**RE: HLP Endodontics, 10429 Lagrima Del Oro NE
Grading and Drainage Plan
Engineer's Stamp Dated 6-29-15 (File: F21-D063)**

**RE: Grading and Drainage Plan
F21-D063
10429 Lagrima del Oro**

**RE: HLP Endodontics, 10429 Lagrima Del Oro NE
Grading and Drainage Plan
Engineer's Stamp Dated 6-03-15 (File: F21-D063)**

FIRST FLUSH REQUIREMENTS

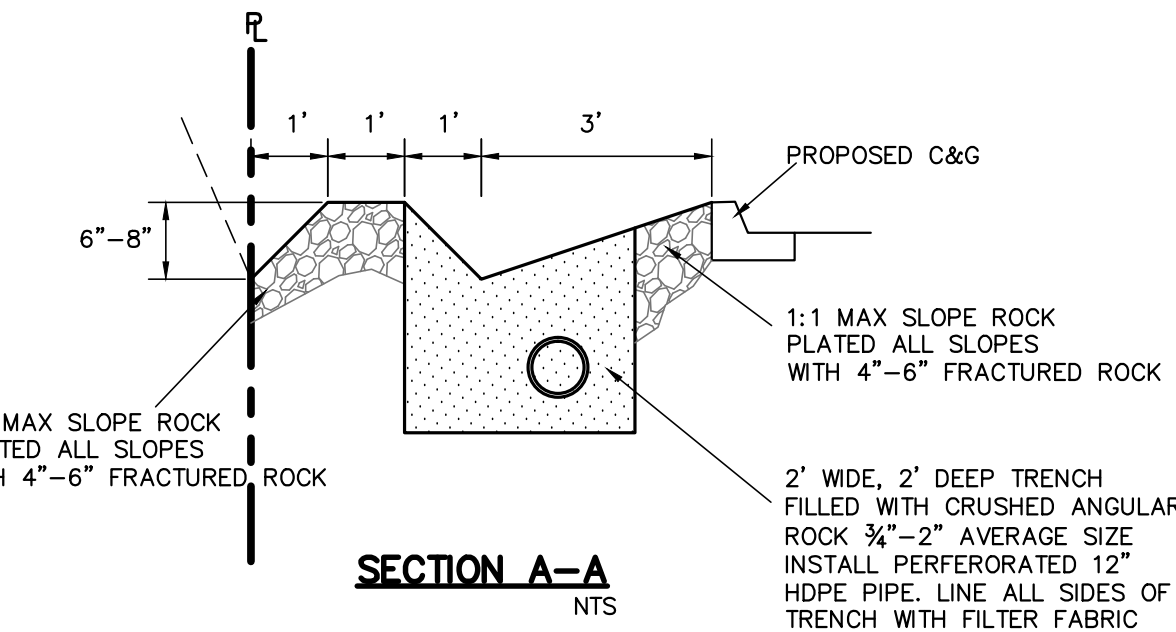
- 2) Reference COA Standard Drawing 2236 for the construction of the sidewalk culvert.
- 3) Approximately 10% of the site drains to the first flush ponds on the east side as indicated by the roof drainage boundary. An insufficient percentage of the first flush volume is provided along the west side even though this is where the vast majority of the site drains. Is there opportunity to provide first flush volumes within the landscaped areas at the northwest and southwest corners of the site?

- 4) Where it says "Volume – 24 cf per dam", add language indicating that this is for the "first flush", and provide the total volume for the first flush within this area.

1. We have revised the plan due to the slope concerns, we have proposed a first flush retention trench rather than the small ponds. The trench allows for the slope and swale to be constructed, the volume of the trench is provided.
2. We have added the reference.
3. We have modified the plan such that all the flow passes through a first flush system.
4. We have revised the plan to provide the first flush with a trench and have labeled as such.
5. We have revised the cross sections and added slope protection.
6. We have labeled the bio swale as 4-6" fractured rock.
7. There is no detail sheet, the comment was a remnant from a different response letter.

SECTION B-B NTS

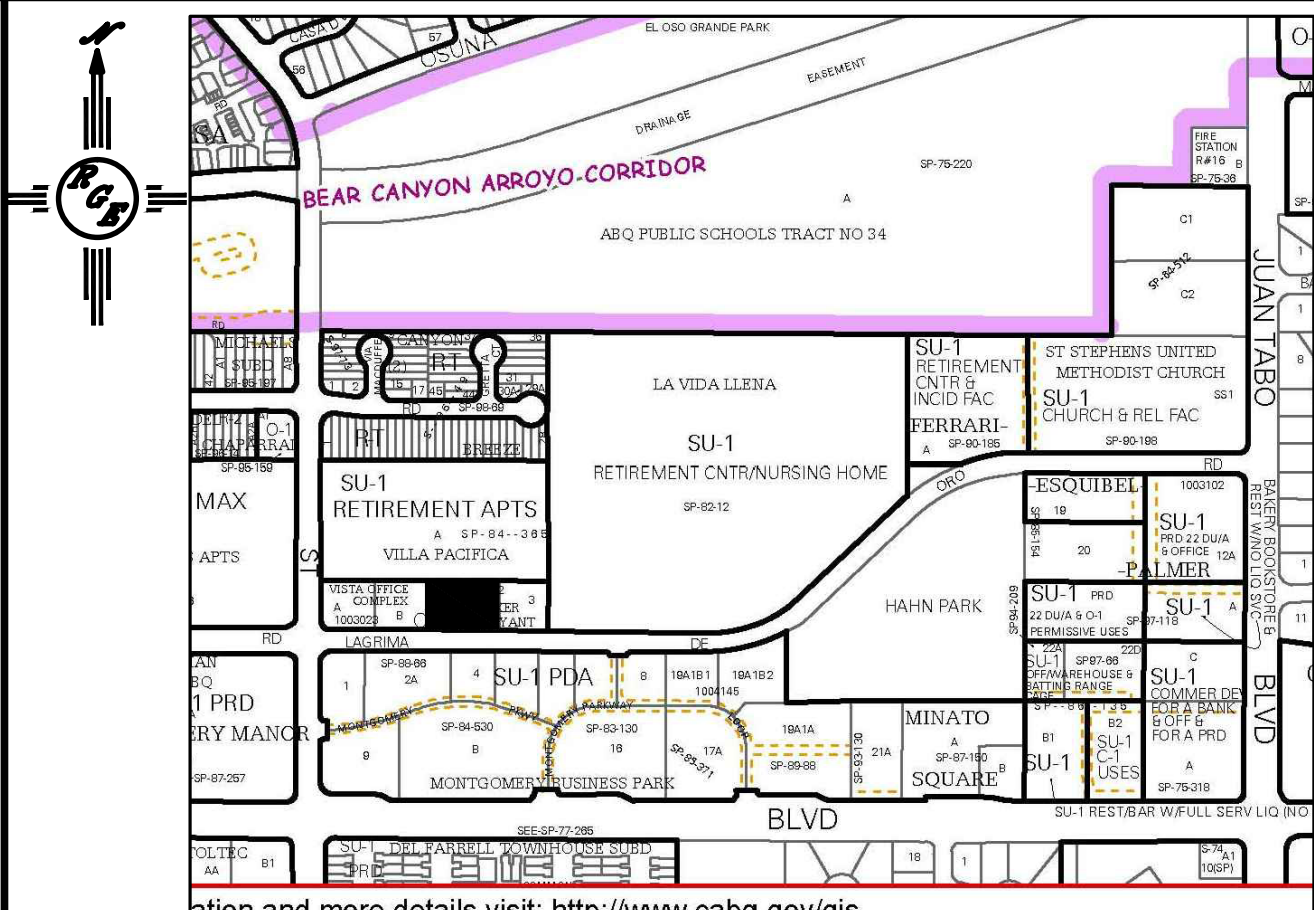
-
- 5) On cross-section A-A along the west property boundary, the slope to the west of the berm be called out as 3:1 since it is right along the property boundary without protection.
 - 6) Call out depth of 4-6" cobble within the bioswale.
 - 7) The referenced detail sheet in the letter also needs to be provided.
